Brislington Meadows - Landscape Comments - Application Ref. 22/01878/P

Notwithstanding this, we provide below a response to the comments raised by the Landscape Officer. However, these comments are made on a without prejudice basis and noting that these are all matters for detailed design stage, when matters relating to proposed landscaping and layout are for full consideration.

The following images, taken from the indicative sections plan submitted (Drawing No. 7456_017ZB), illustrate how the proposed landform closely follows the existing topography of the site.

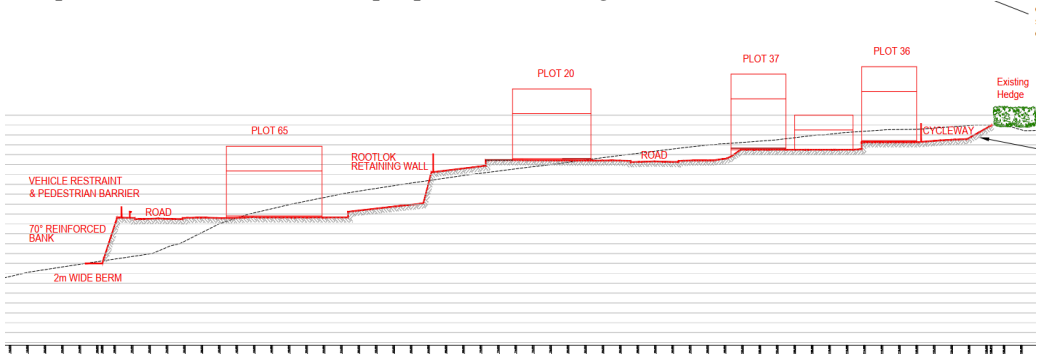
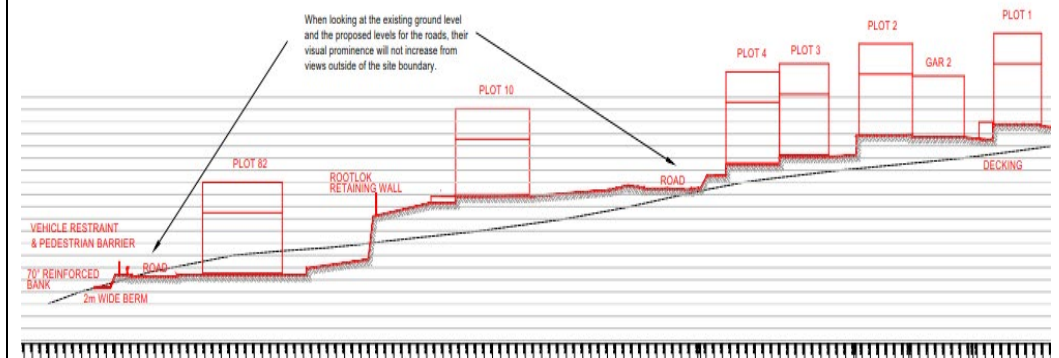
BCC Comment	Design Team response
<p>To accommodate a traditional housing typology with single flat finish floor level the site is proposed to be reprofiling with substantial earthworks. This has resulted in an engineered approach to the sloping topography of site with extensive;</p> <ul style="list-style-type: none"> retaining walls and tanking to the buildings faces; earthworks throughout the site fundamentally altering the landform. 	<p>The planning application is made in outline and the Illustrative Masterplan submitted is therefore for indicative purposes only to show how one way in which the parameter plans could be delivered. The final approach to dealing with layout and the significant level changes will be decided at reserved matters planning stages.</p> <p>The illustrative layout developed to date has been based on balancing cut and fill effectively over the site, creating accessible streets by minimising the amount of level change on the primary and secondary streets and creating flexibility on plot for a variety</p>

of built solutions to be developed, ranging from under-build, opportunity for split-level housing, terraced garden walls or larger retaining structures at plot boundaries.

As such, the proposals work with the natural topography/landform of the site as much as possible and this has helped enable the masterplan to:

We disagree that the proposed development is overly engineered. The proposed development generally follows the natural slope of the hill as close as practicably possible with general reprofiling of around 1m as shown by the indicative cut and fill model and cross-sections above. Furthermore, the retaining walls have been spaced across the development profile as it follows the topography down the hillside. This has enabled retaining walls to be kept relatively low, unobtrusive and hidden within plots, although the steepest areas have necessitated higher retaining walls up to 3-4m in discrete parts of the site.

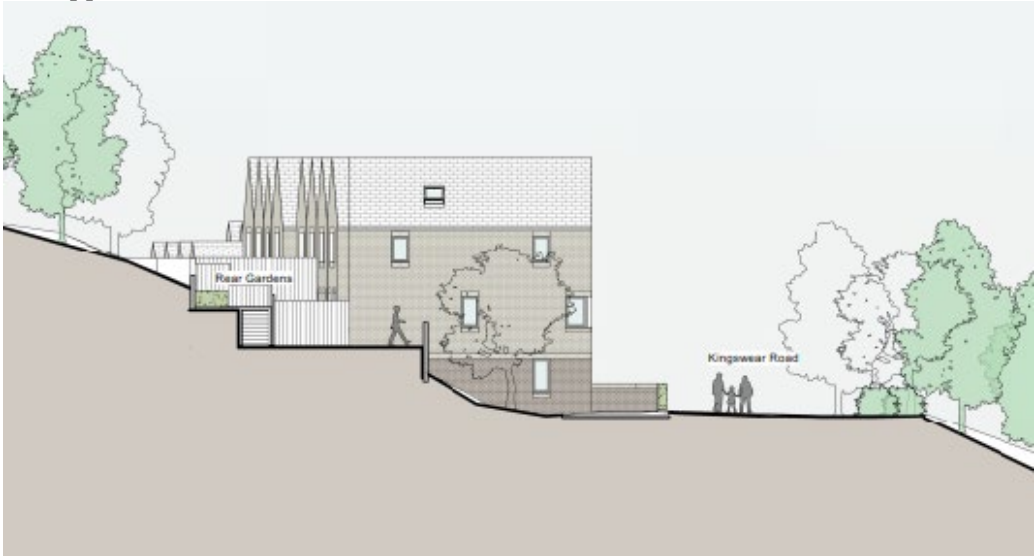
- the usability the garden areas with:

See comments below in relation to the back gardens.
